LETTER OF TRANSMITTAL FOR THE 19 JANUARY 1990 LETTER FROM U S EPA REGION
IV REGARDING INCINERATOR ASH AT THE HERBICIDE ORANGE SITE AND 22 MARCH
1990 LETTER REGARDING U S AIR FORCE RESPONSE TO U S EPA REGION IV
COMMENTS ON THE DIOXIN RISK ASSESSMENT WITH A
11/3/1990
DEPARTMENT OF THE AIR FORCE

SUBJECT: REPLY TO EPA REGION IV COMMENTS ON TCDD RISK ASSESSMENT - ASR-05-90

Reply to EPA Region IV Comments
on the Ground Water Model for NCBC

Figure 1. Revised source release model for the TCDD release from the NCBC Herbicide storage area.

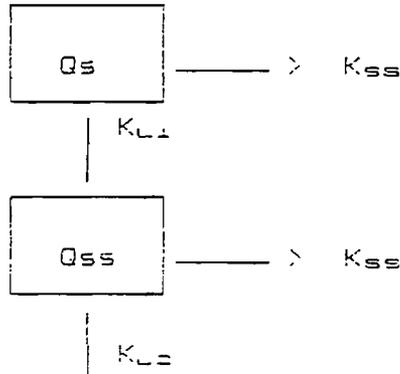
The comment concerned the degradation rate of TCDD in the groundwater and the assumption of zero concentration initial condition.

Degradation rates for TCDD in soil and surface water were reported in the Superfund Exposure Assessment Manual draft version printed in 1988. Subsequent versions of this document have omitted the Physical and Chemical data for Contaminants. Schaum (1984) reported half lives for TCDD in soil of 10 to 12 years. This process was attributed to photolytic (sunlight) degradation, thus degradation of TCDD in the groundwater would not occur by this process. In the original risk assessment, degradation in the groundwater was assumed to occur at some rate between the soil and surface water rates. The authors were not aware of the mechanism by which TCDD degrades at the time the original transport calculations were performed, thus new transport calculations were performed that ignore degradation in the groundwater. Degradation in the soil was taken into account since TCDD on the surface is susceptible to degradation from sunlight. These calculations are presented in Section 2 of this document.

The source term model was revised because the available literature (Schumm, 1984) indicates TCDD degradation occurs by photolytic reaction. Surface contamination would be most susceptible to this reaction and the effectiveness of this process would decrease with soil depth. Schumm recommends using a half life of 10-12 years for TCDD contamination at or near the surface and a half life greater than 100 years for deeper contamination.

In order to account for the different degradation rates of TCDD in the soil, the source term model was broken up into two compartments: a surface compartment and a subsurface compartment. The surface compartment represented the first 6 cm of soil and was characterized by a 12 year half life. The second compartment represented soil depths from 6 to 61 cm and was characterized by a TCDD half life of 100 years. The leach rate constant (as defined in the original document) operated on both compartments as shown in Figure 1.
